RE: Quarterly Inspection; AFIN 18-00094; Permit Number 0245-S1-R1.

Arkansas Department of Environmental Quality Solid Waste Management Division Class 1 Landfill Inspection

Si	te Name	Crittenden County Class I	County	Crittenden	AFIN	18-00094					
Fa	cility Address	South off Hwy 70	Phone Number	LF: 870-732-4290 Off: 870-732-6580	Permit Number	0245-S1-R1					
Permittee Address		Crittenden Co. Judge	E-Mail Address	arredllc@swb.net		PDS # 071257					
Da	ate	4-17-13	Entry Time	11:45 AM	Exit Time	1:30 PM					
		Regulation 2	2 – Operation	al Standards							
X R	Depicts Violation Repeat Violation										
	Regulation	gulation Item Description Comments									
	411(l)	Adequate employee facilities									
	421(a)(b)	Record keeping meets requirements specified by regulations									
	417	Access requirements									
	411(j)	Adequate provisions for backup equipment									
	421(d)	Waste receipt records, ticket system maintained									
	411(k)	Telephone system & written emergency response plan on site									
	423(b)	Annual compliance inspection by registered professional engineer

1&2

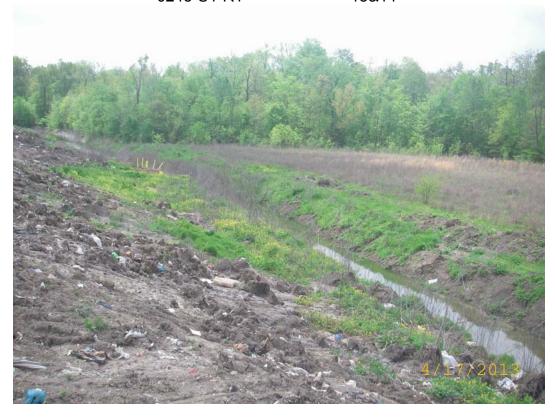
Comment	s: The active working face v	was not a practical working	size. Mo	easured 150 feet by 2	50 feet in size. Photos 1&	2.				
	Reg. 22.427 (d) Erosion Control - The design shall also include berms, swales, benches, downchutes and other measures as appropriate on steep slopes to minimize erosion. In areas where flow quantity and velocity warrant, rip rap, gabions, revetments, or other protection shall be provided.
